URGENT RECALL NOTICE

November 8, 2006
FMI: 15046; 15057; 15087

Subject: Product Safety Issues

Affected Products: OEC® 9900 Elite, OEC®, 9900 Elite^{MD} Motorized C-arm System, OEC® 9900 Elite^{NAV}

SUGGESTED PLACEMENT OF STICKER ON SYSTEM

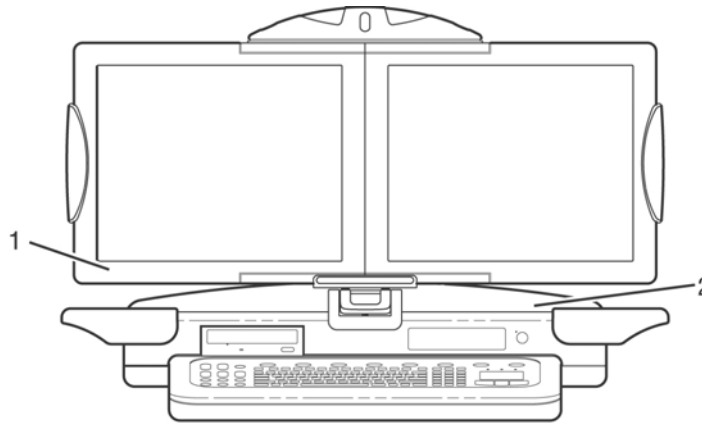
GEHC OEC has become aware of a potential problem with the above-indicated products where the C-arm may lock-up. Specifically, during system usage, the system may fail to function (produce live x-rays), and the collimators may close. In addition, the system display may indicate that the system is active (such as sound and/or light displays) when, in fact, the system is not producing live x-rays. The left monitor of the system will not update (no live fluoroscopy). There will be no radiation emission occurring despite the audible and visual indicators. If it is suspected that the system has emitted an uncommanded radiation exposure the user should contact GEHC to have the exposure logs reviewed to confirm if an exposure was made.

In critical clinical scenarios in which the C-arm is being used to make real-time therapeutic decisions or guide real-time interventions, a system lock-up may cause a procedural delay. Users should always be certain that the images shown on the Left Monitor are refreshing and are in fact live x-ray images (one indicator of this status is that the word "live" displayed on the screen).

Should your OEC System experience a Lock-up, restarting (rebooting) the system should restore system functionality. The restarting (rebooting) sequence for the 9900 Elite System takes approximately 3 minutes to restore functionality. **Images saved prior to the system locking up will be restored and are retrievable. Images not saved prior to the system failure will not be restored.**

Enclosed is a sheet of supplemental stickers, including instructions for attachment, that demonstrates the restart steps. These stickers should be promptly attached to your system(s) as indicated below (suggest placement in location #2). These instructions are also located in the Operators Guide.

SUGGESTED PLACEMENT OF STICKER ON SYSTEM

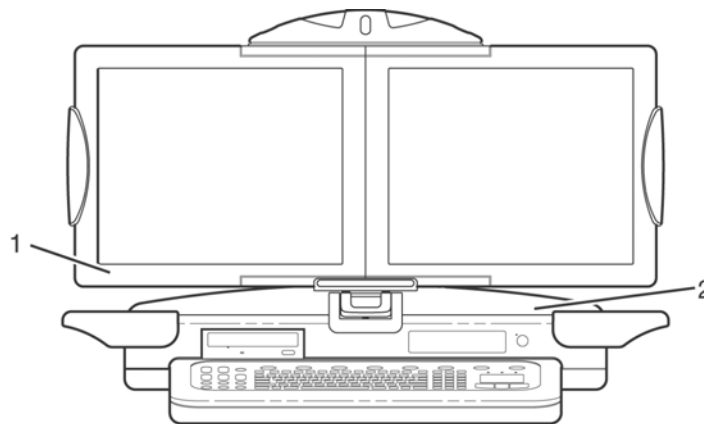
When the image directory is accessed and thumbnail images are used to recall patient images, incorrect images may be displayed or there may be an inability to locate images on the system. The actual images, however, are labeled with the correct patient information, and may be located within another patient’s file.

To reduce the occurrence of this issue The GEHC OEC service team will be contacting you to upgrade your 9900 system’s software to 6.15.3. Additional solutions to eliminate this issue are under investigation by GEHC OEC. To reduce the occurrence of this issue users should follow the correct power down procedure. The power down procedure is described in the Operators Guide and on the supplemental stickers enclosed with this notification.

The supplemental stickers should be installed on your system(s) promptly following the enclosed instructions and as indicated below (suggest placement in location #2).

SUGGESTED PLACEMENT OF STICKER ON SYSTEM

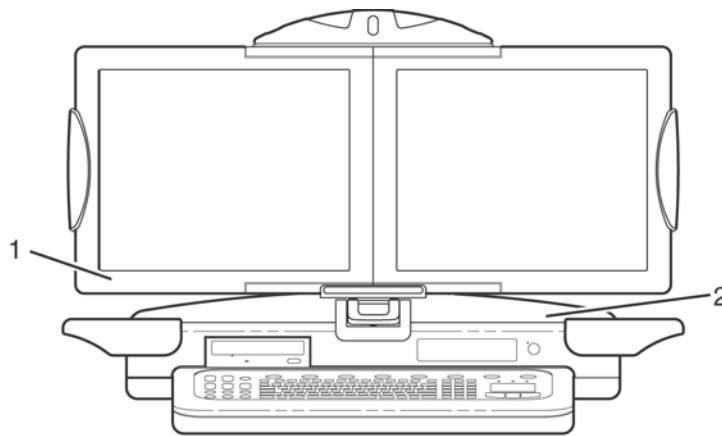
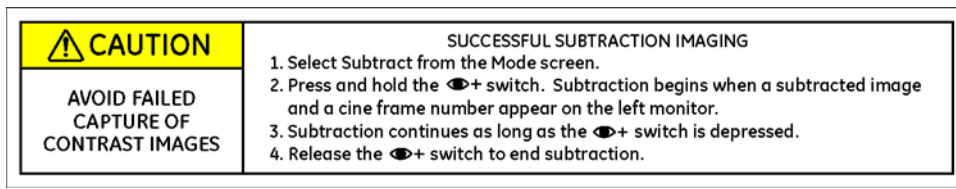
During subtraction a different static image may appear under the real time image.

When acquiring the pre-injection image at the beginning of a subtraction run, the user must allow the system to enter subtraction mode before ending the exposure. A user can confirm that they have entered subtraction mode by the appearance of a subtracted image and the cine frame number on the display screen on the left monitor. If the user does not see the frame number and the subtracted image on the screen the image should be re-acquired prior to continuing with the study. Currently, the only available option, should this situation occur, is to reacquire the image if it serves the best interest of the patient.

Supportive labels containing the above information have been included with this notification. These labels should be placed on your systems following the instructions included with the labels and as indicated below (suggest placement in location #1).

SUGGESTED PLACEMENT OF STICKER ON SYSTEM

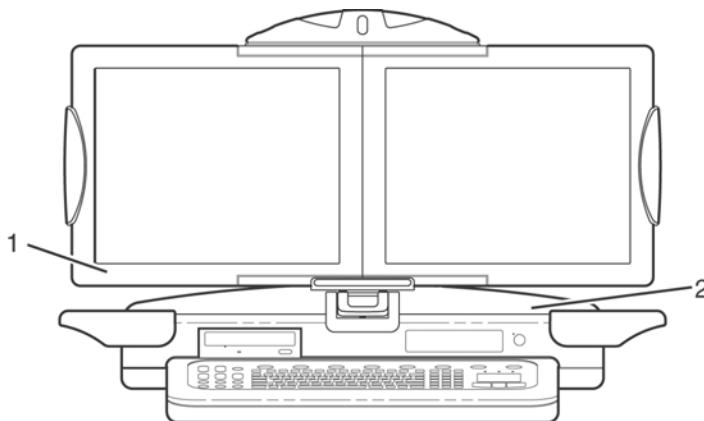
OEC 9900 Elite, OEC 9900 Elite ^{NAV} may stall during its boot cycle causing a delay in usage. The most common symptom of an incomplete boot cycle is when the workstation progress bars stall at $\frac{3}{4}$ of completion. The vacuum fluorescent display on the C-arm will stop on 5 arrows. If this condition persists for longer than a minute, the system is stalled.

Rebooting the system should clear the issue and restore system functionality. When rebooting the system for this issue, before reapplying power, it is important to place the power switch in the OFF position and wait **10 seconds**. Should the system fail to reboot a second attempt at rebooting may be required. These instructions are also located in the Operators Guide.

Enclosed is a sheet of supplemental stickers, including instructions for attachment, that demonstrates the restart steps. These stickers should be promptly attached to your system(s) as indicated above (suggest placement in location #2).
